ADDENDUM NO. 04

Date of Issuance: January 7, 2025

Project: **2024 Jersey Village High School Renovation**
 Cypress-Fairbanks Independent School District

Texas Arcadis Inc.
 Project No.: 202319

1 SITE PLAN - AREA '5'
1" = 30'-0"

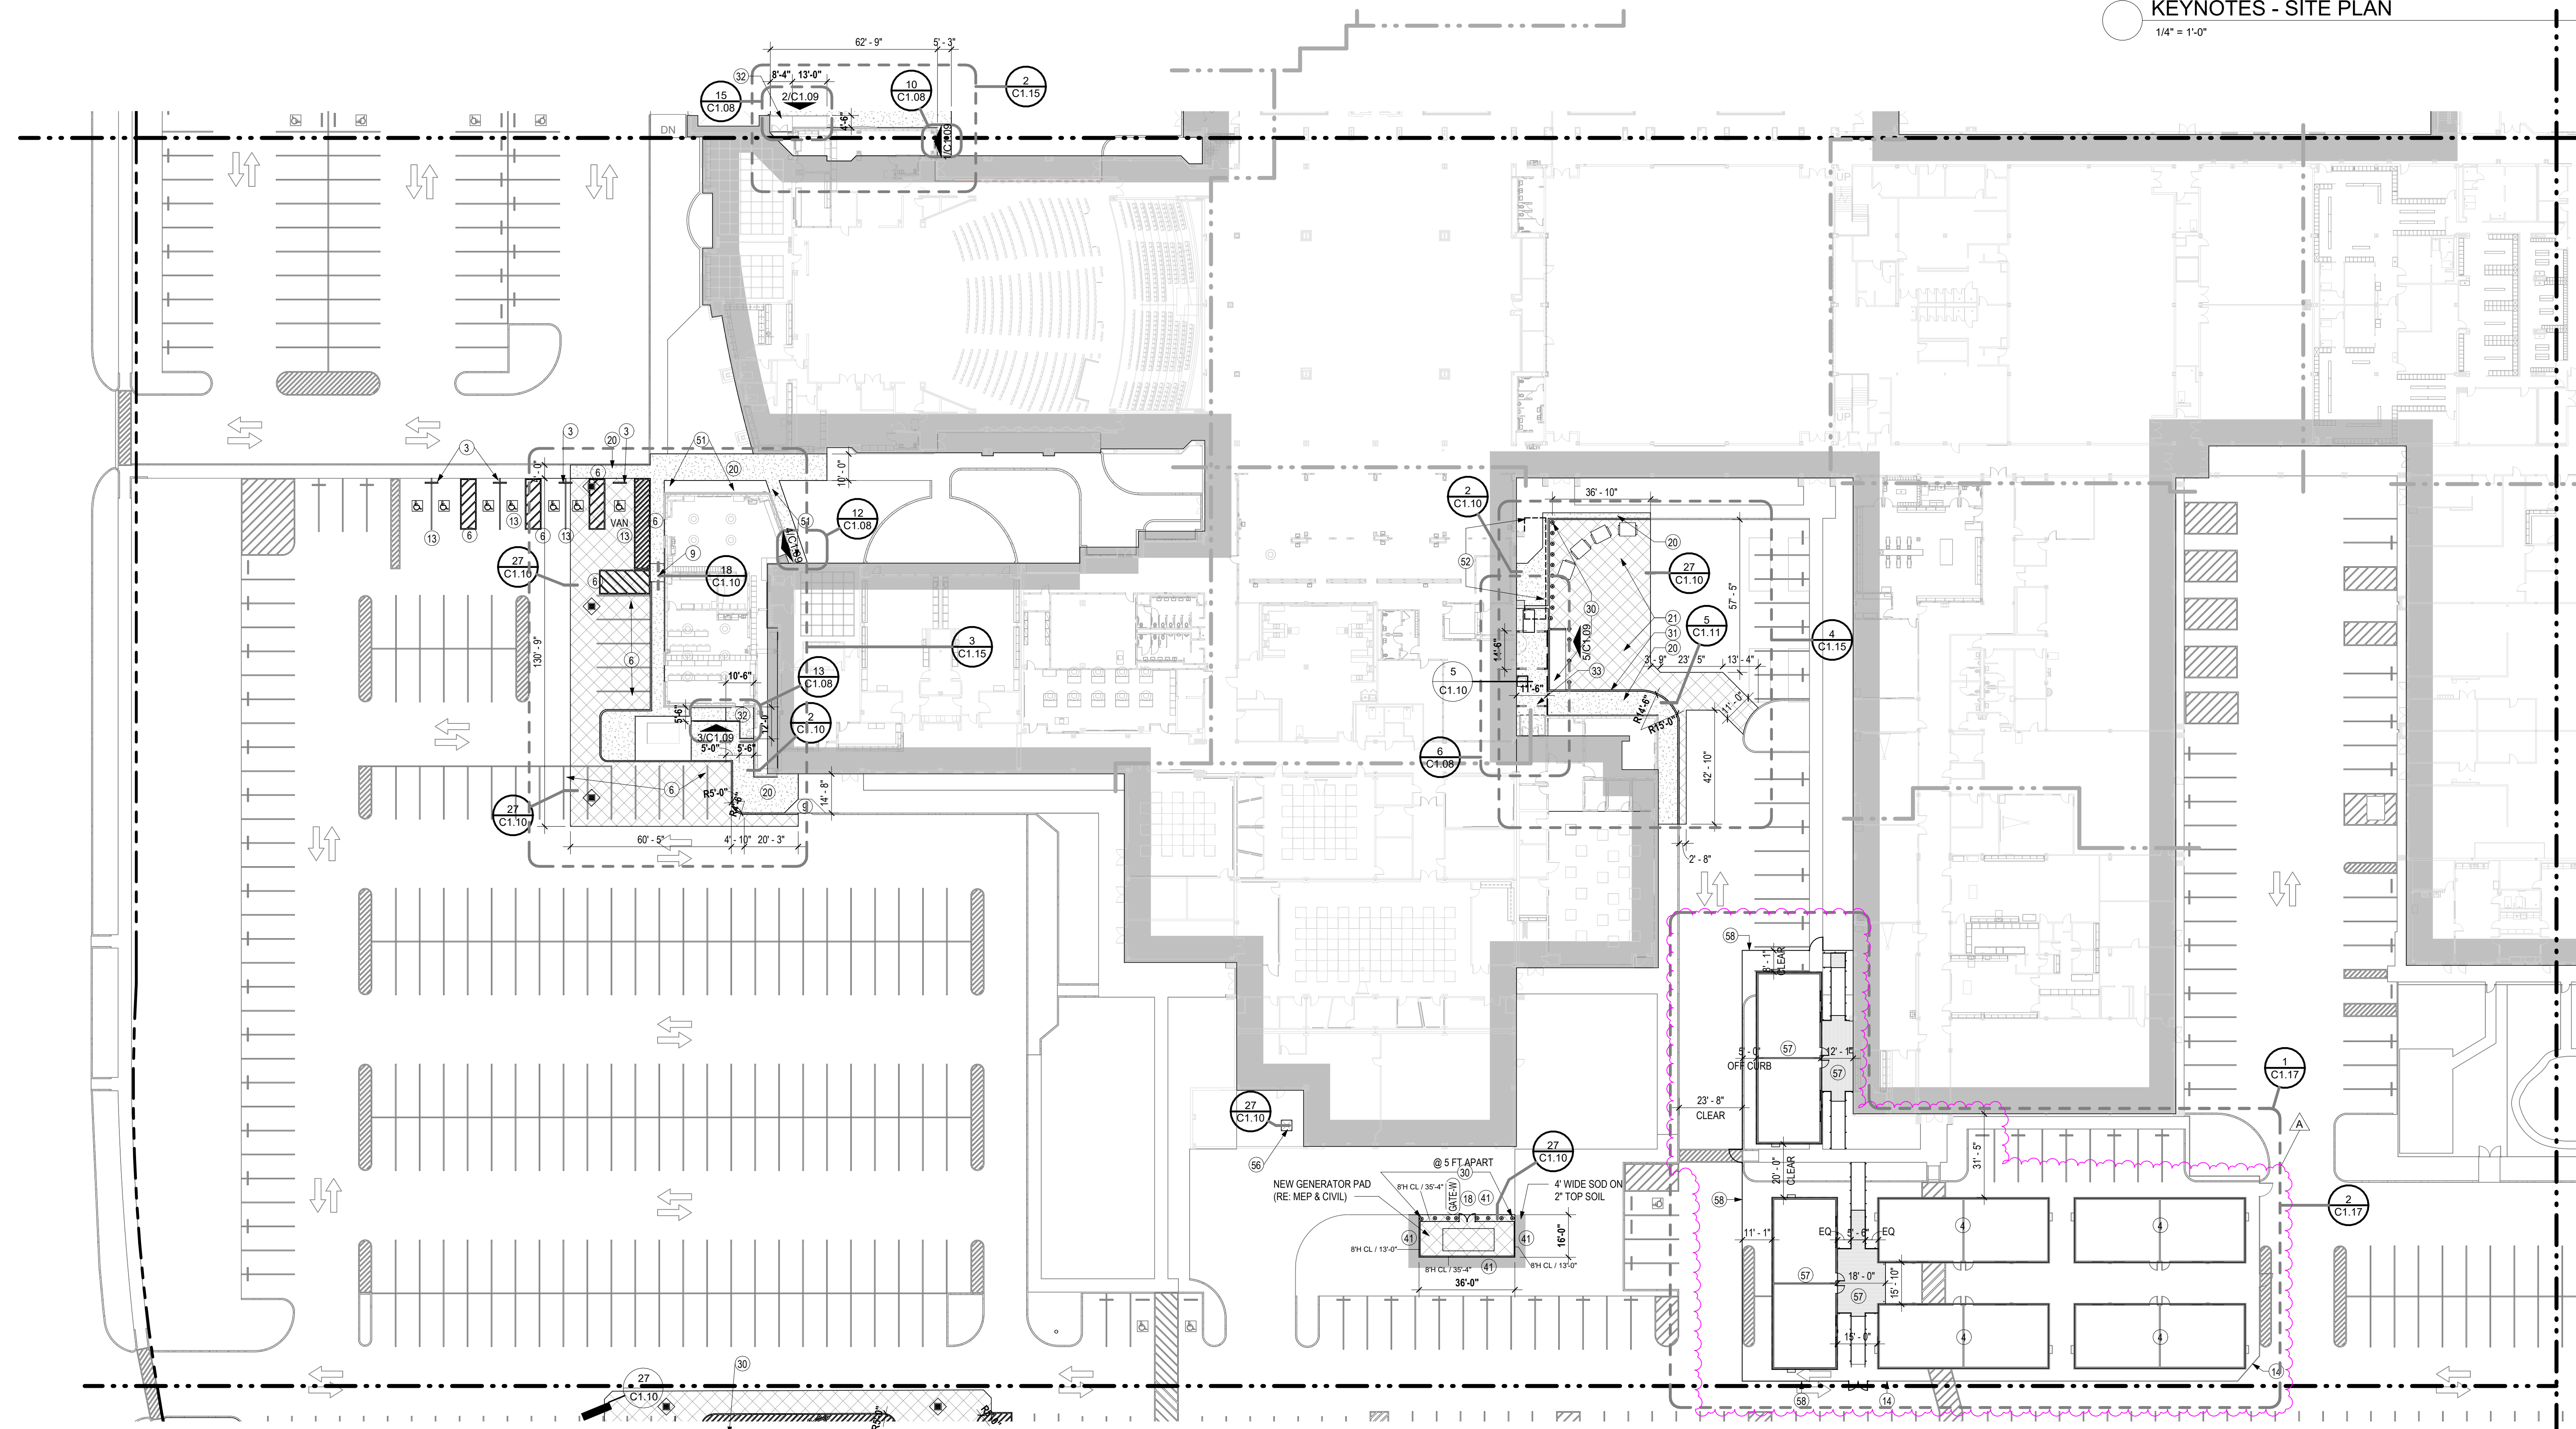
27. Sheet C1.05 – AREA ‘5’ SITE PLAN
 - a. Provide two (2) new portables, new wood decking, ramps, stairs and canopy
 - b. Provide new ornamental security fencing to match existing

- c. Add keynote 4, 14, 57, 58 to KEYNOTES - SITE PLAN
28. Sheet C1.07 – Metal Storage Building
 - a. Adjust crop view of detail 1/C1.07.
 - b. Move text ‘NEW 6’ C.L. GATE’.

14 EXT ELEV - E
1/8" = 1'-0"

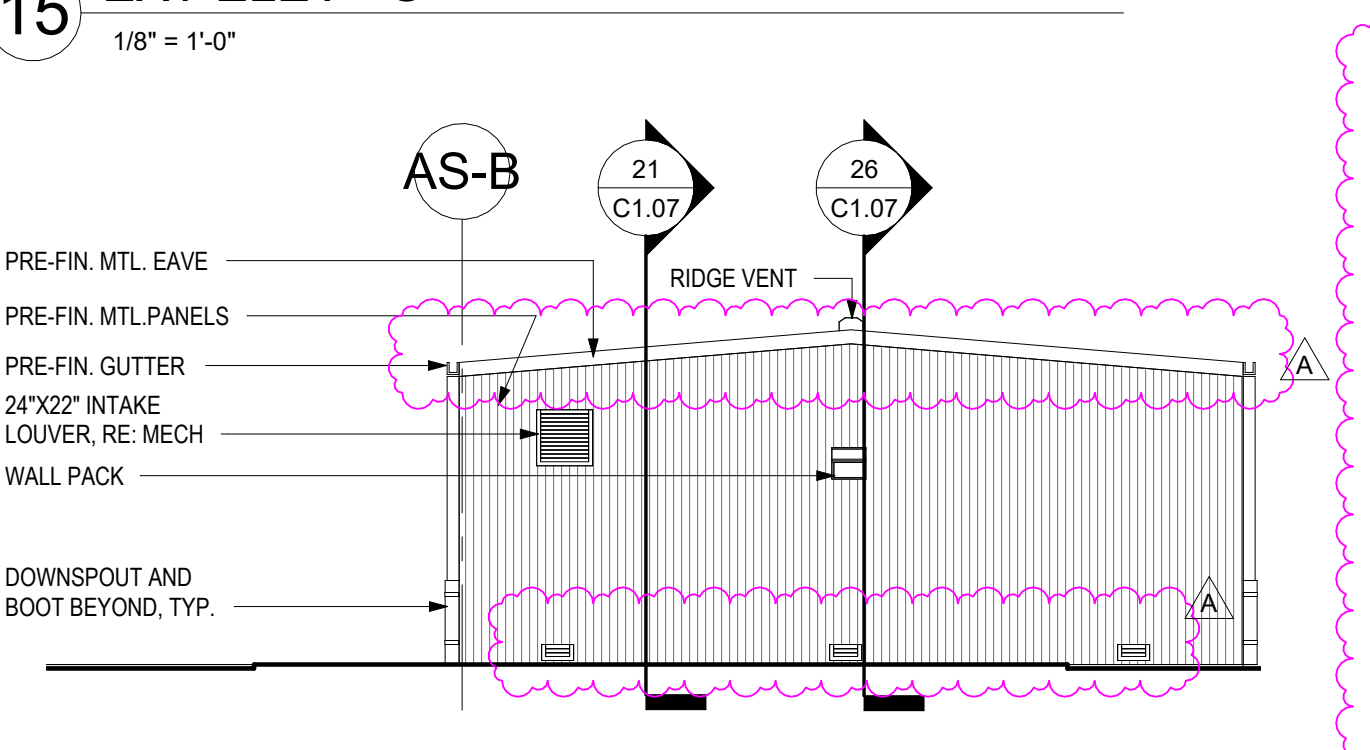
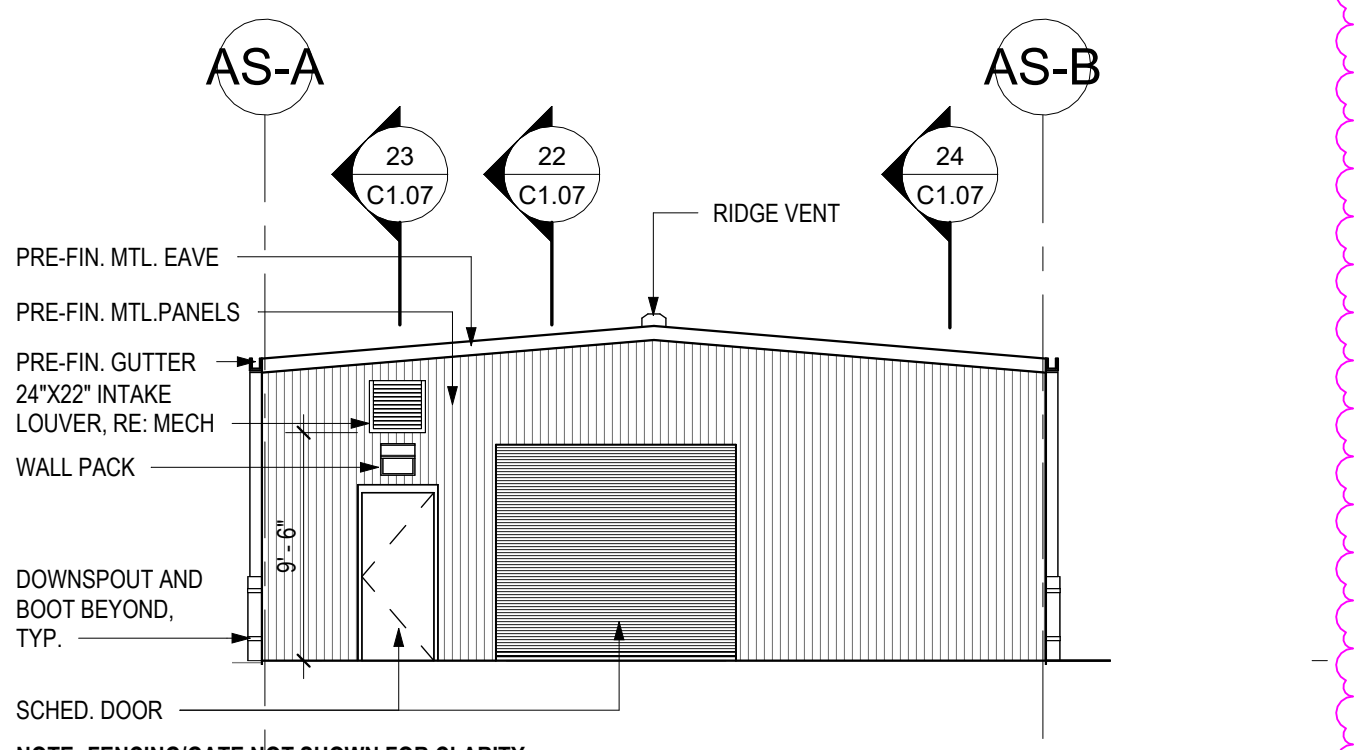
- c. Remove details 27 & 28, relocate to sheet C1.12.
 - d. Make entire wall same material elevation 14/C1.07.
 - e. Text leader arrow clarification detail 16/C1.07.

10 PRESSBOX - WALL SECTION
3/8" = 1'-0"

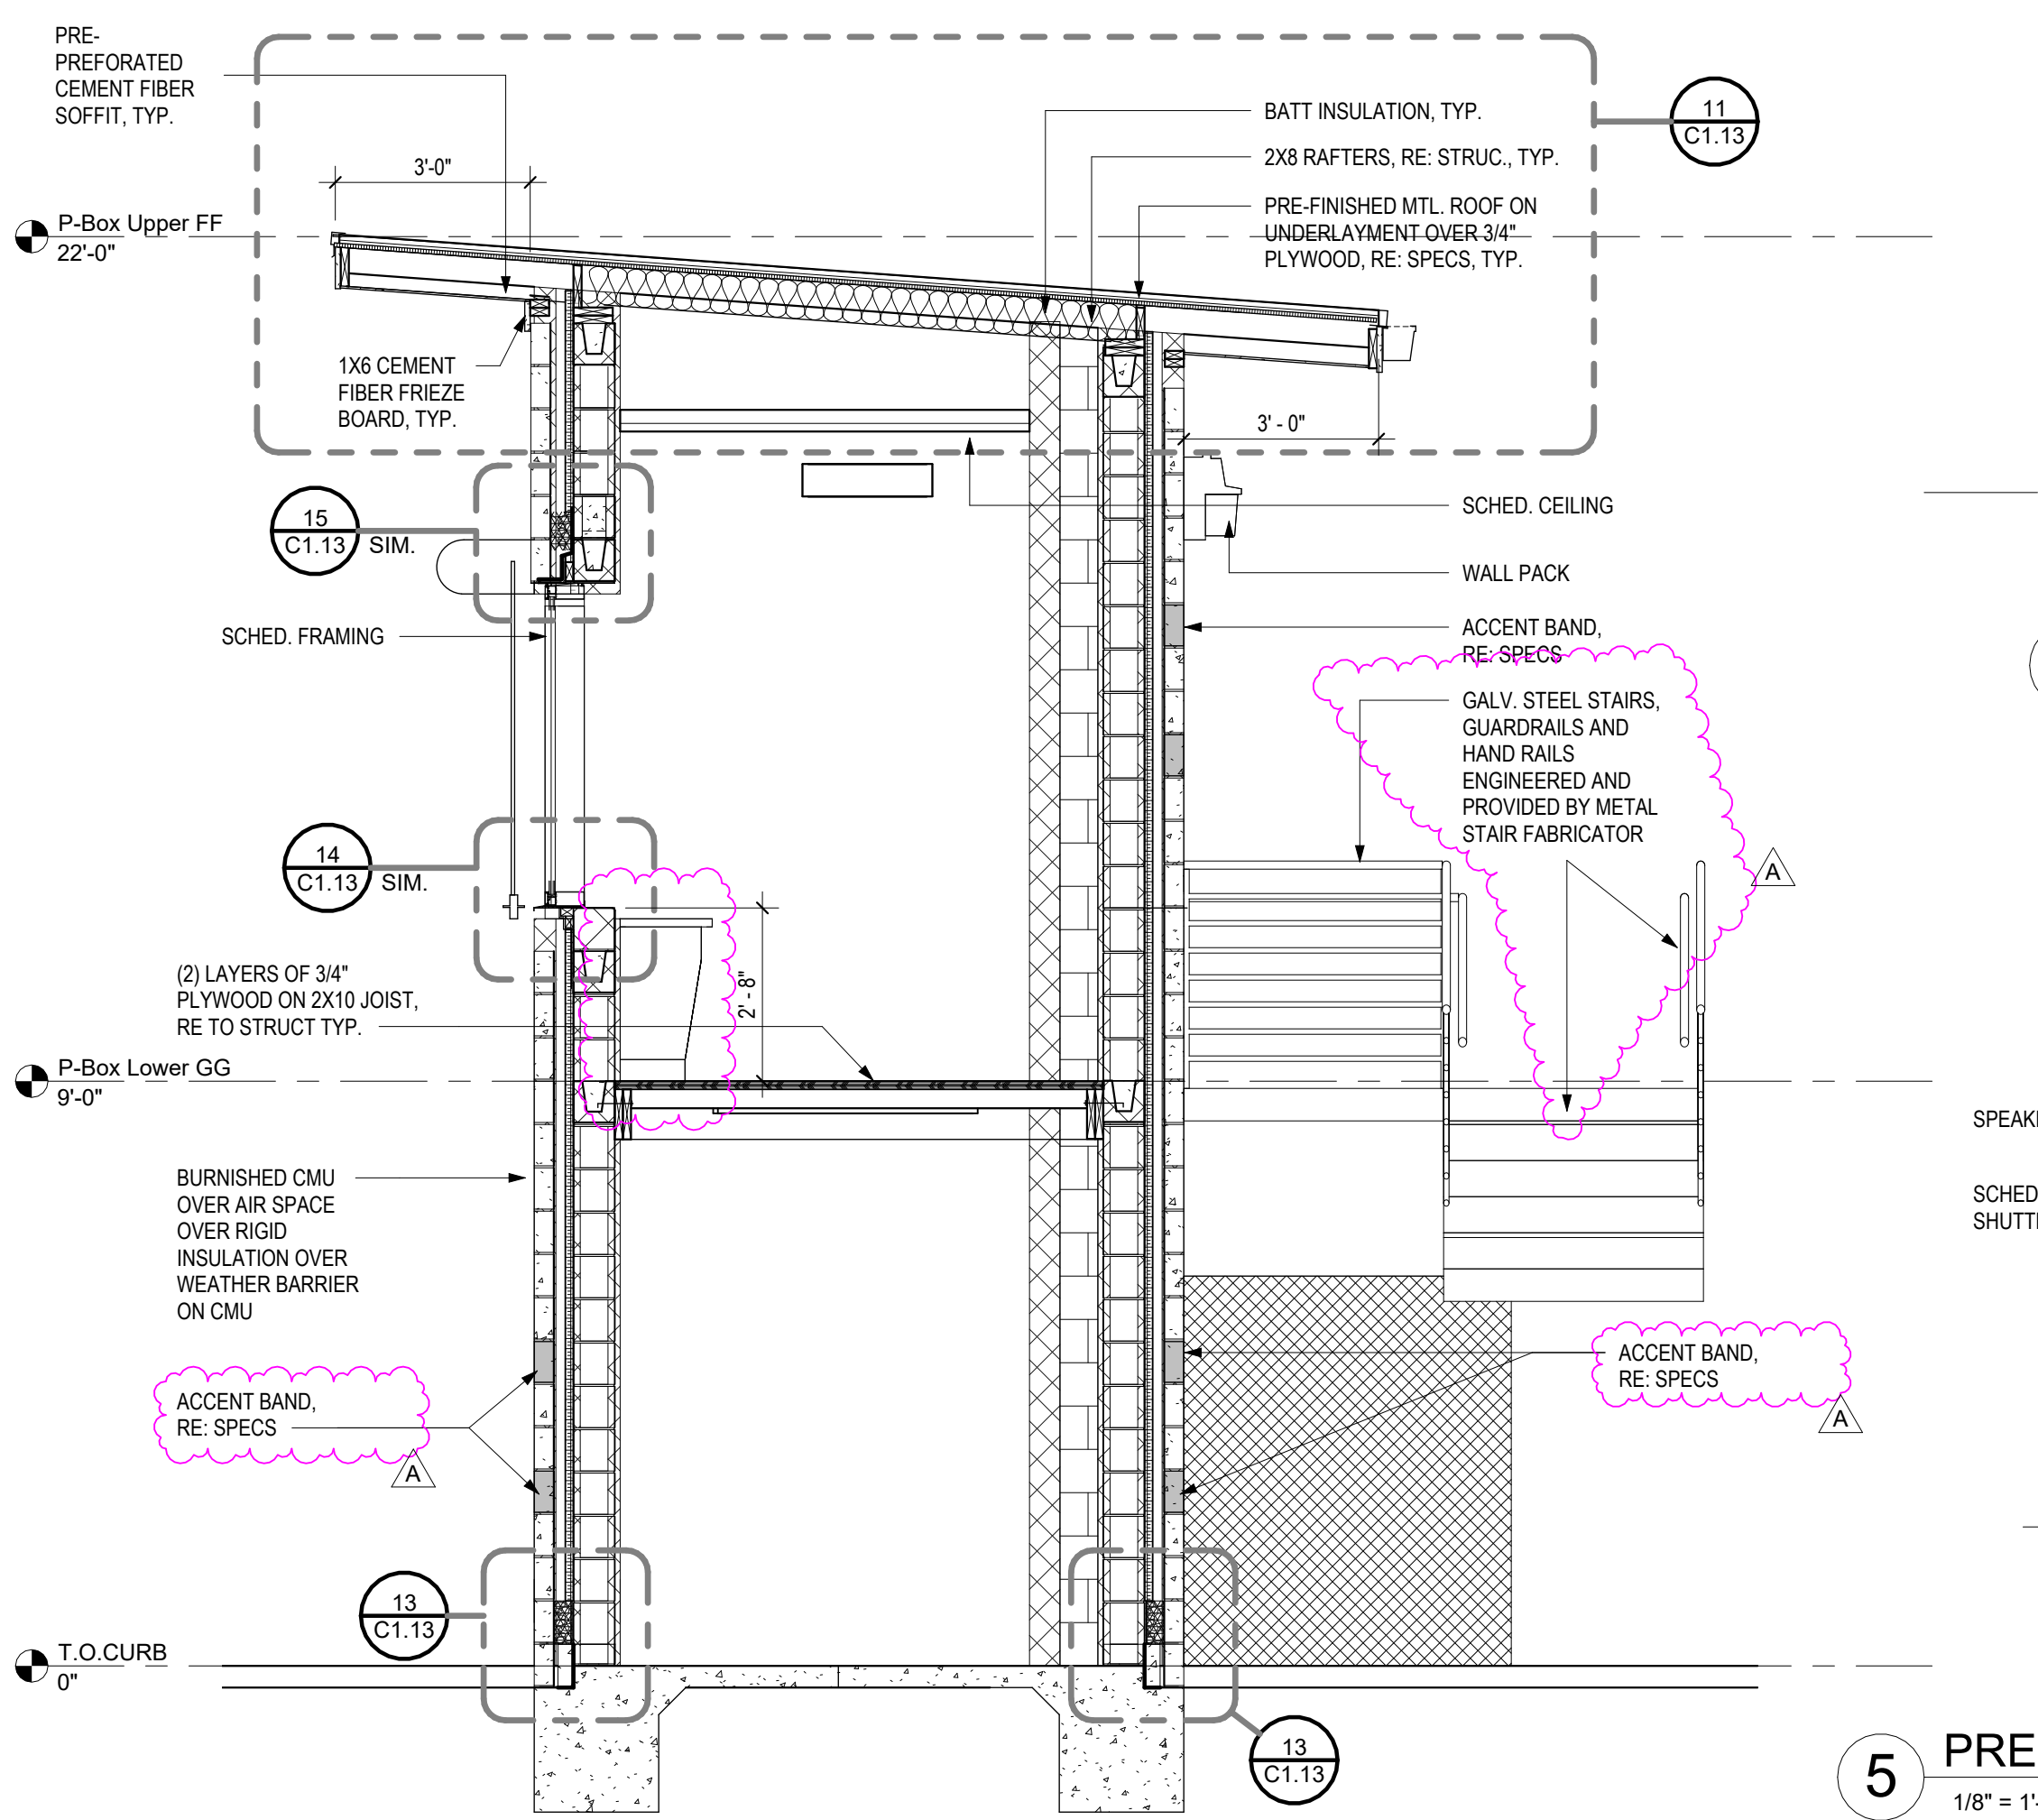
- g. Revise pressbox millwork and counter per reissued sheet.
 - h. Revise accent band note at detail 10/C1.13 per reissued sheet.
 - i. Add light fixtures to RCP details.
